April 27, 2015

**Re: QSRP Developments Inc.  
Proposed Residential Subdivision  
309 Zephyr Road, Township of Uxbridge  
Response to Peer Review  
Project No.: 300034602.0000**

**DILUTION AREA**

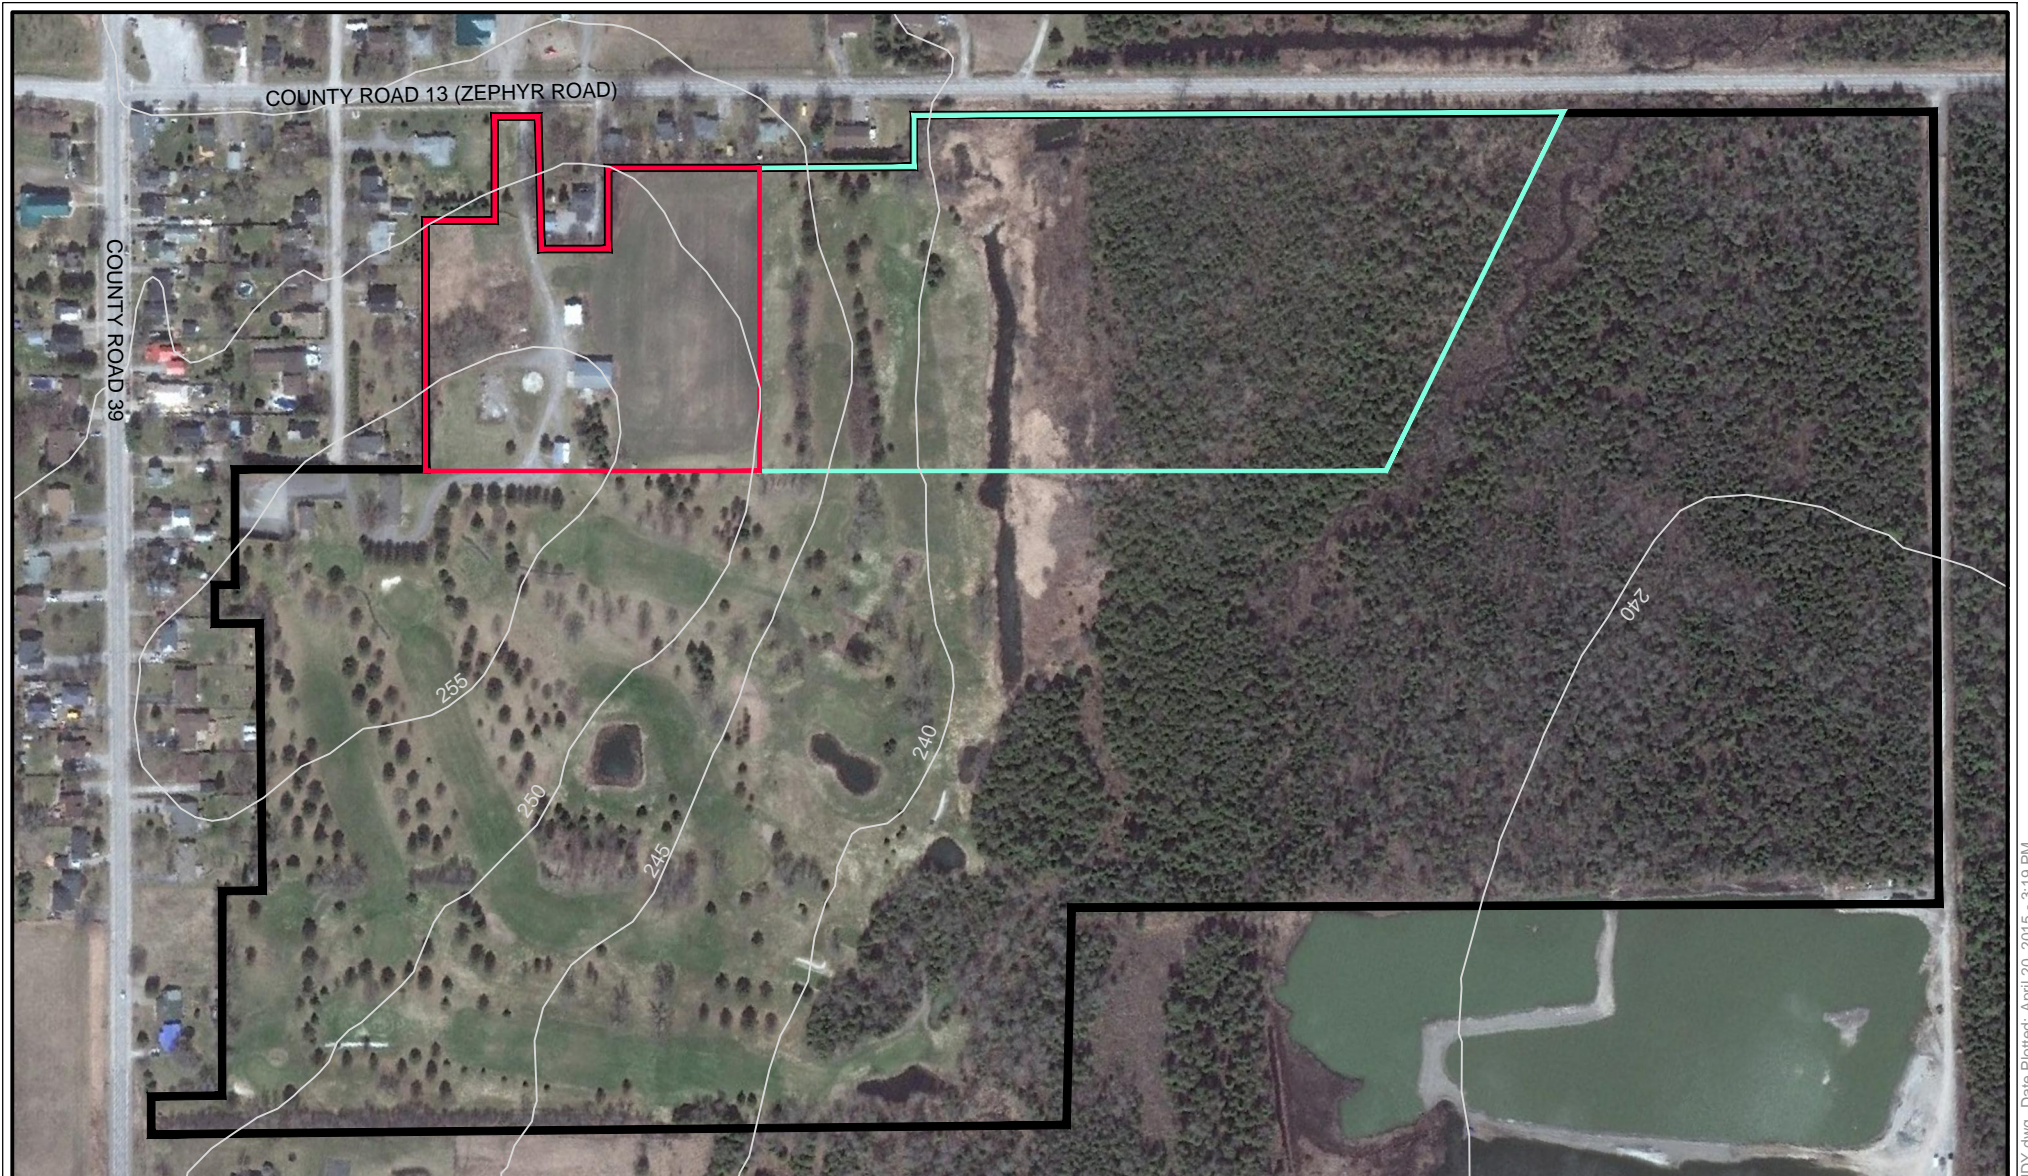
The predicted nitrate concentration exceeds the objective limit of 10 mg/L. The previous reports by Grace & Associates also predicted nitrate concentrations above the criteria, and subsequently proposed increasing the dilution area to the east and south of the subdivision. The proposed subdivision is currently part of a larger property that includes a golf course and a wetland area (see Figure 1 attached).

The previous report noted that shallow groundwater flow was predominantly in an easterly to northeasterly direction. This coincides with the overall ground topography and surface drainage (see Figure 1). The proposed development is on the northeast side of an elevational high with the ground sloping down to the north and east. Drainage will also be primarily toward the wetland as a likely local groundwater discharge feature. An additional drainage area is outlined on Figure 1, from the eastern boundary of the subdivision to the low point in the wetland. No development will occur in this area. This additional area covers 6.91 ha and including it in the dilution calculation results in a nitrate concentration of 4.6 mg/L. This is well below the 10 mg/L criteria. Even if the additional area only included the portion of the golf course west of the linear water feature visible on Figure 1, a nitrate concentration of 8.2 mg/L would still be achieved.

Legal consultation suggests that a mechanism can be placed on a portion of the existing golf course/wetland property that will exclude future development. The excluded future development would be sewage systems that require onsite disposal.

As noted above, the nitrate calculation does not take into account other forms of attenuation. The presence of vegetation, in particular deeper rooted shrubs and trees in the natural areas will provide additional attenuation. If development is controlled on the golf course east of the subdivision, there will be more than sufficient nitrate attenuation for the subdivision.
